Request for Information

Project Description:	<u>Bagley Streetscape</u>	RFI #:	<u>MC RFI-003 (Rauhorn RFI 001)</u>
Location:	<u>Bagley St, SW Detroit</u>	Ref. Spec:	<u></u> Ref. Drawings: <u></u>

PROJECT DESCRIPTION
DESIGN ENGINEERING FOR BAGLEY LIGHTING UPGRADE
24TH TO THE FISHER SERVICE DRIVE SB
UNDERGROUND CONSTRUCTION PLAN

SHEET UG-01

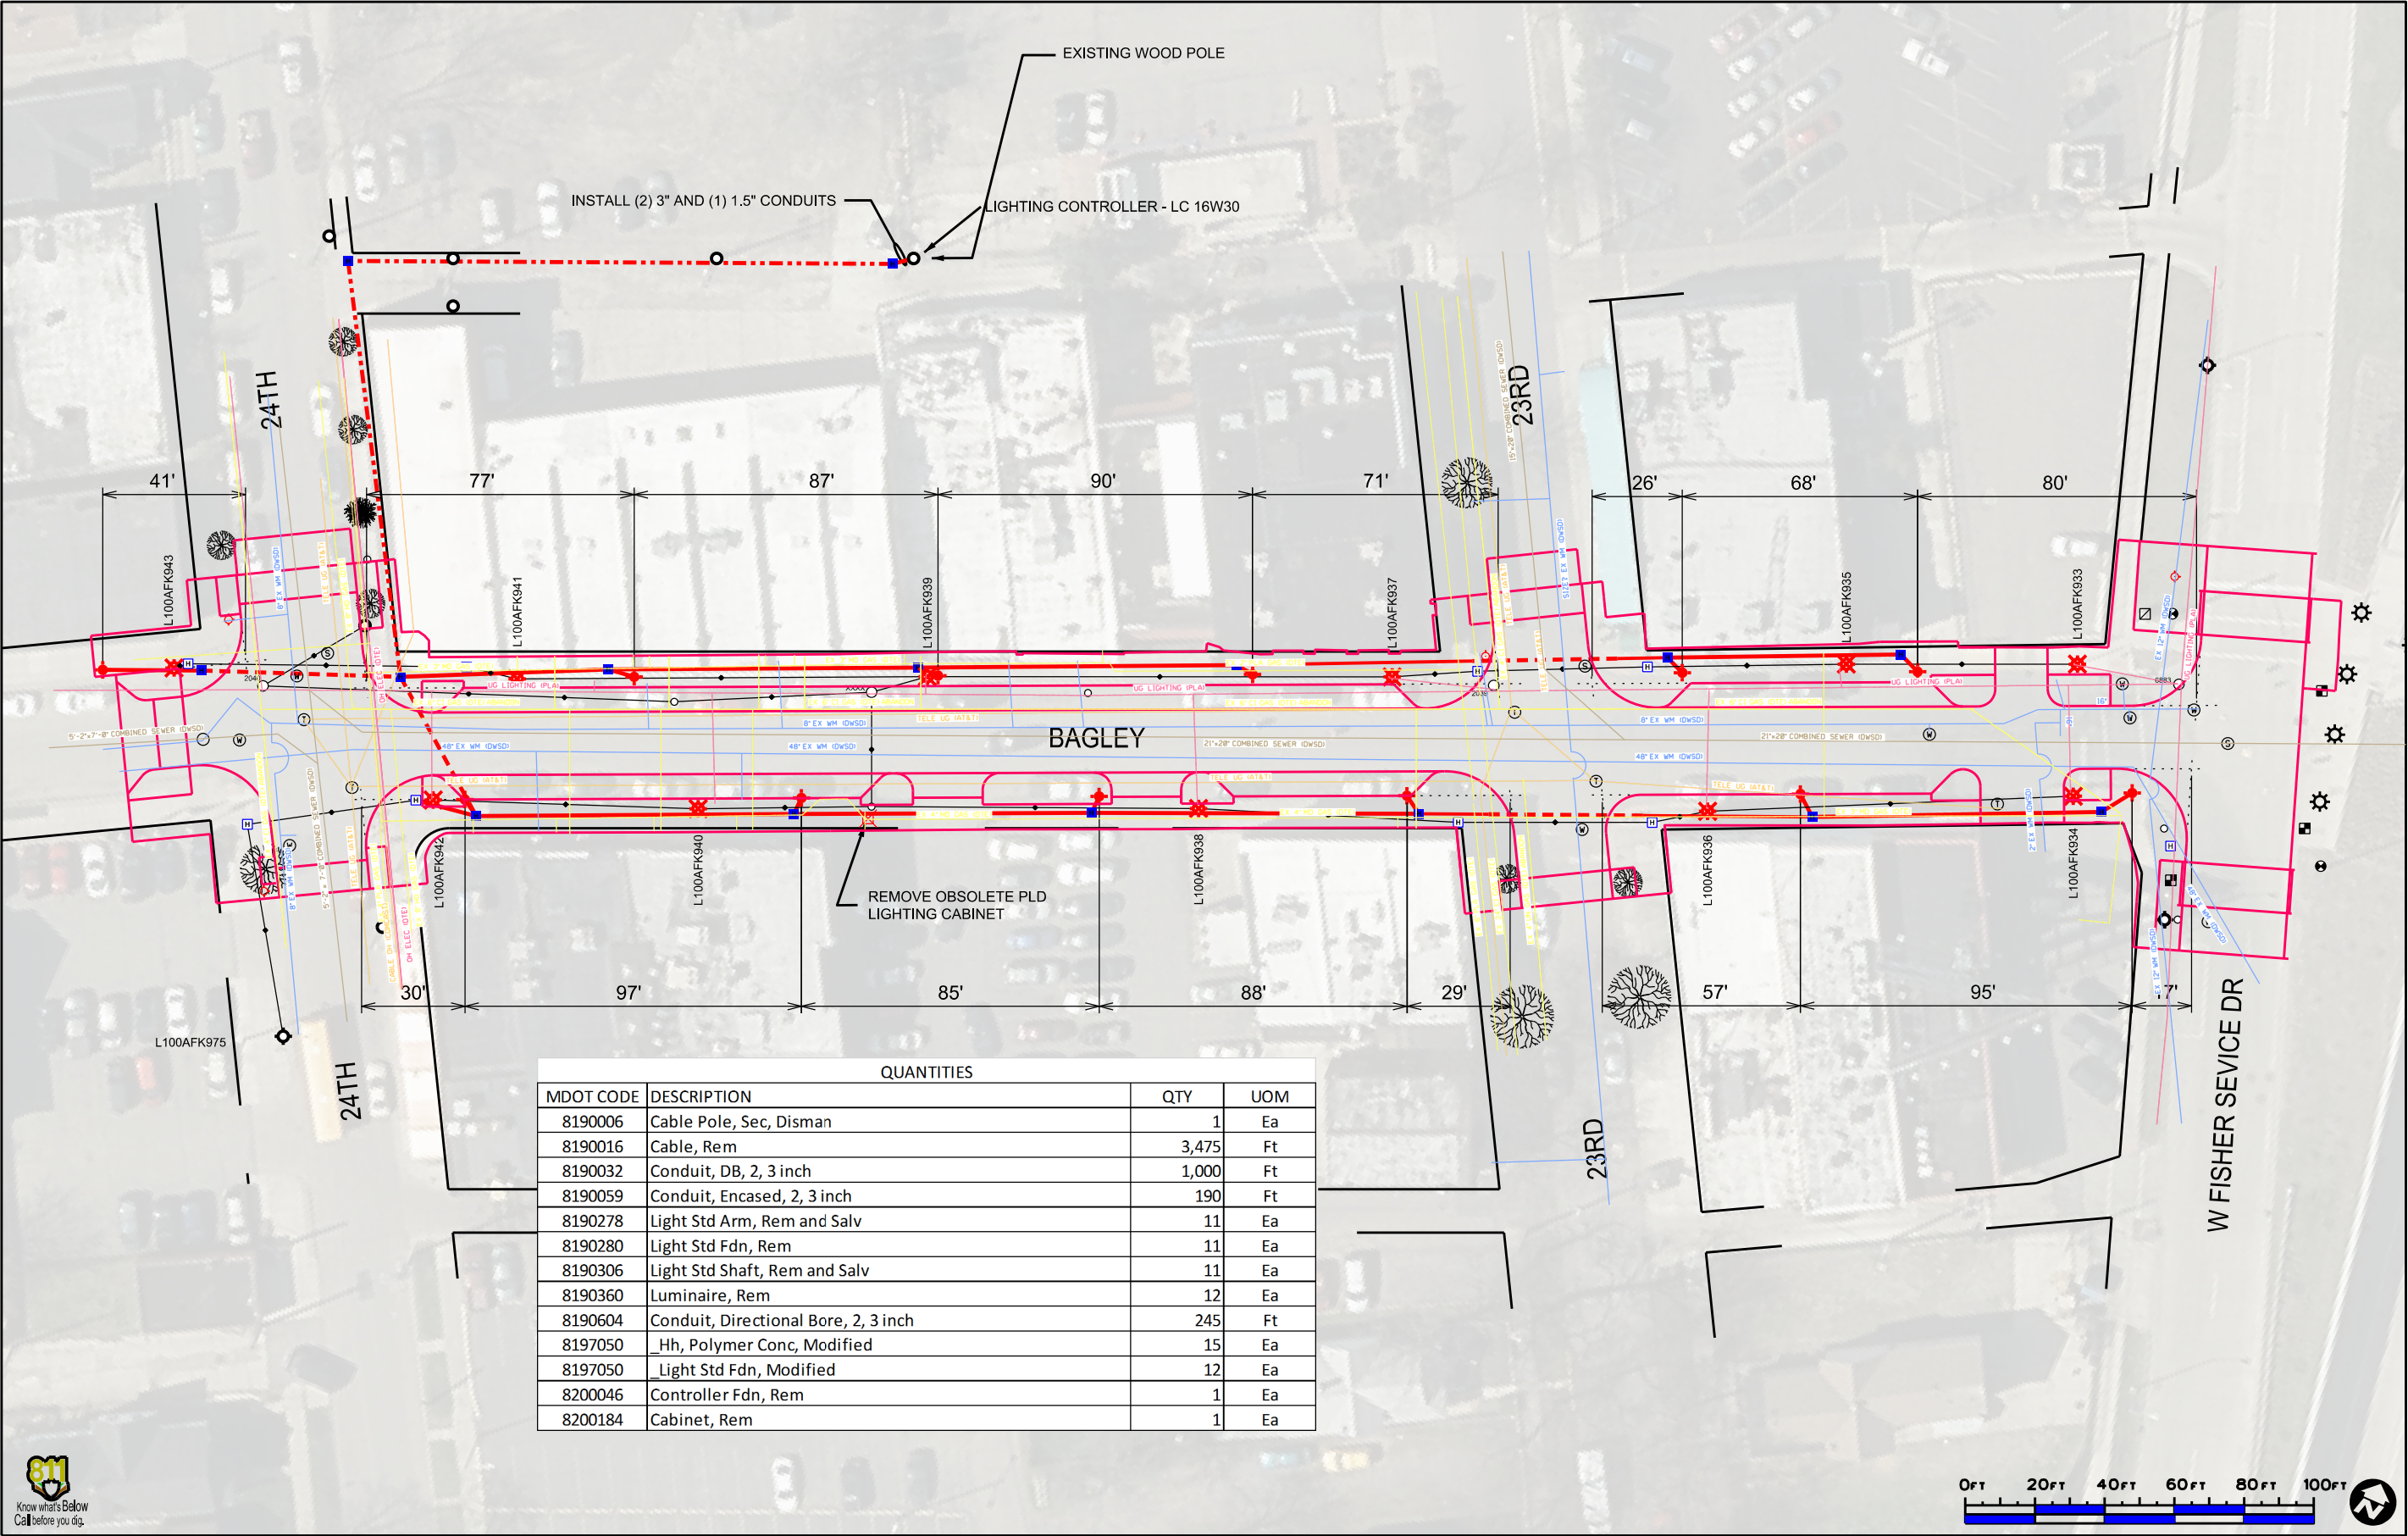
1. Please provide detail for installation of lighting controller LC 16W30 on the existing wood pole.
2. There is a note stating to install (2) 3" and (1) 1.5" conduit from the handhole to the existing woodpole. There are no pay item quantities for this.
3. Is the conduit that goes from the corner of Bagley & 24th Street going North up 24th Street then East down the alley to the existing cable pole existing conduit or will this be new conduit? If it is new conduit how many conduits are being ran and what are the sizes of the conduits? Does Major cement know of these additional removals if it is new conduit?
4. What is to be done to the conduits that are entering into the obsolete PLD Lighting Cabinet?
5. There is no temporary lighting plan. Will there be any requirements for temporary lighting? During the project?
6. Where are the lighting poles to be brought once removed and salvaged?

SHEET IN-1

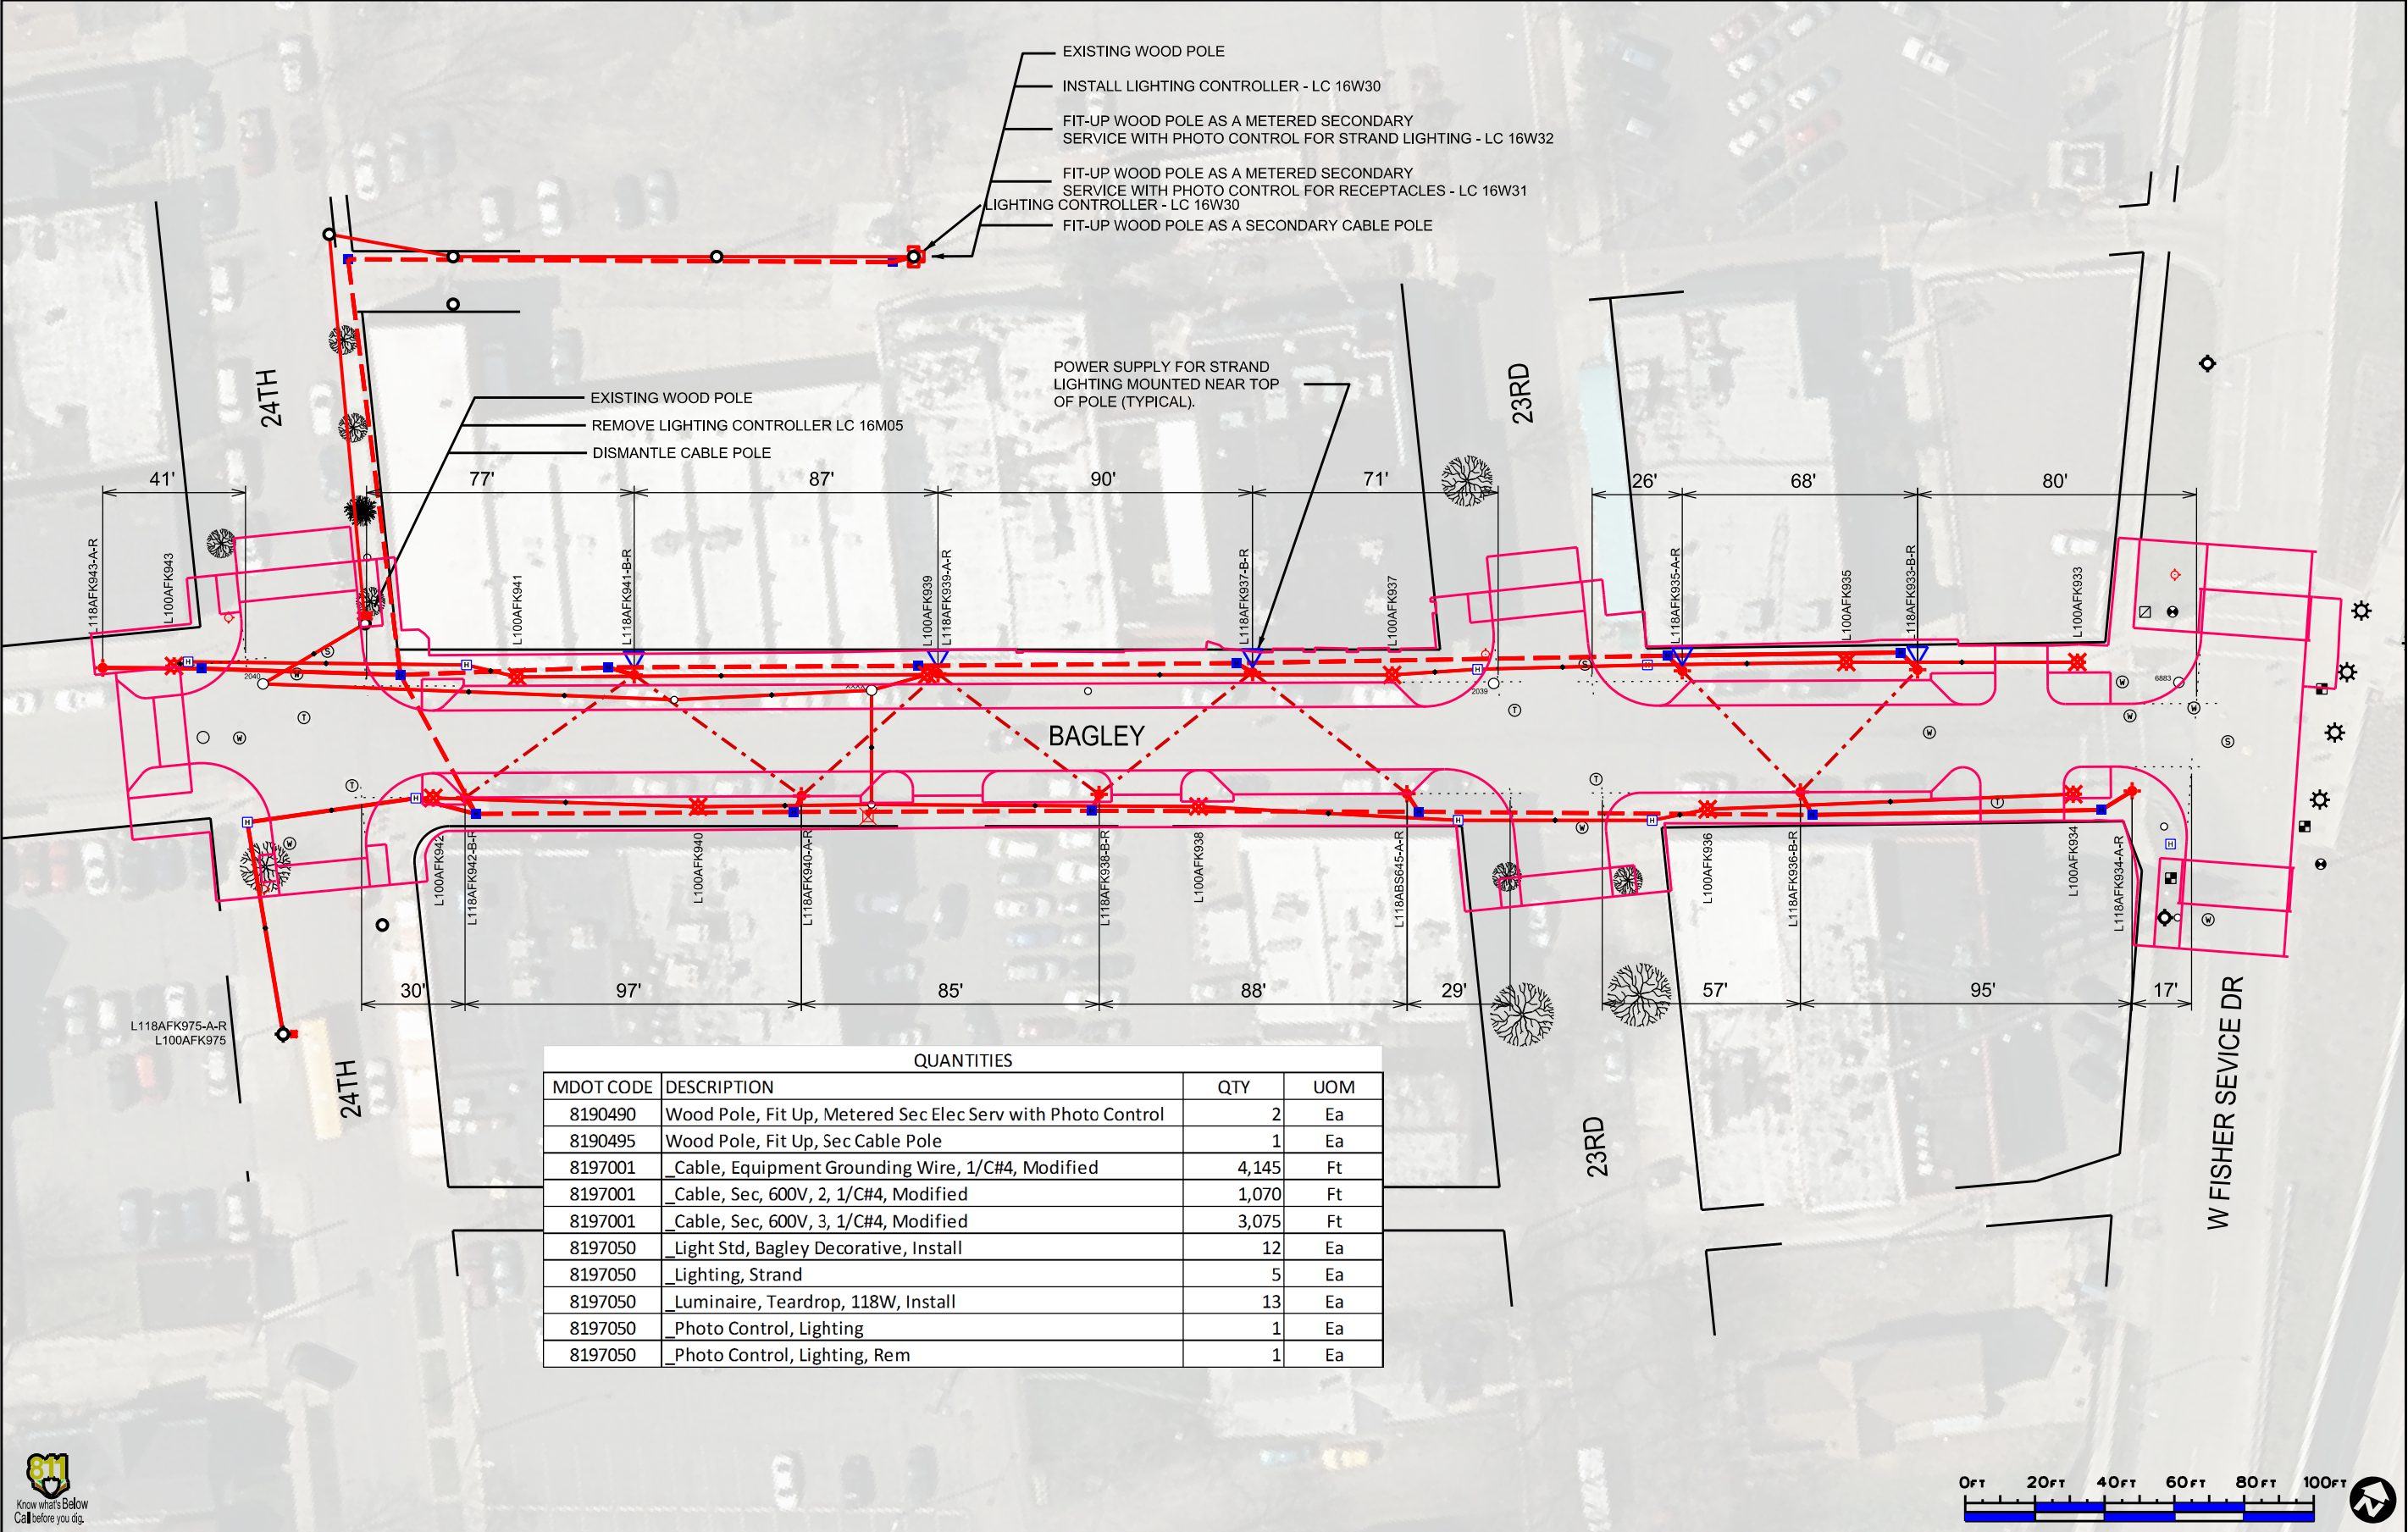
1. Please provide detail for installation of lighting controller LC16W30, LC16W31, and LC16W32 on the existing wood pole.
